Section: XII (Service Bulletins)
Number: 24 65-71

Date : 1/5/65

Cut individual items along broken lines & paste in appropriate section of your Mer-Cruiser Service Manual.

Figure 1. Red Warning Tag

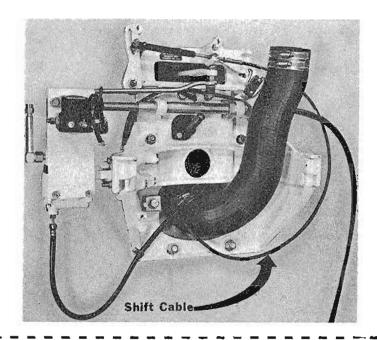
Some MerCruiser IC Stern Drive Units were shipped with an incorrect shift cable warning ta attached to the transom plate assembly. (Figure 1) Later MerCruiser IC shift cables are protected with a spiral protective shield and it is not necessary to clamp the shift cable to

the inner transom plate. Disregard the red warning tag. (Figure 1) and follow instructions in MerCruiser IA-IB-IC "Installation Manual". Route shift cable as shown in Figure 2.

Figure 4. Remote Control Cable Measurement

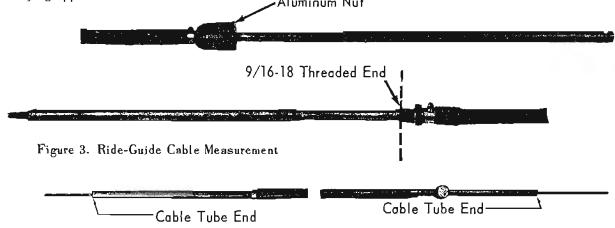
In order to clarify the measurement of Ride-Guide and remote control cables, Ride-Guide cables are measured from the large aluminum nut to the 9/16-18 threaded end (Figure 3), while remote control cables are measured from the end of one cable tube to the end of the other, not to include the inner wire. (Figure 4)
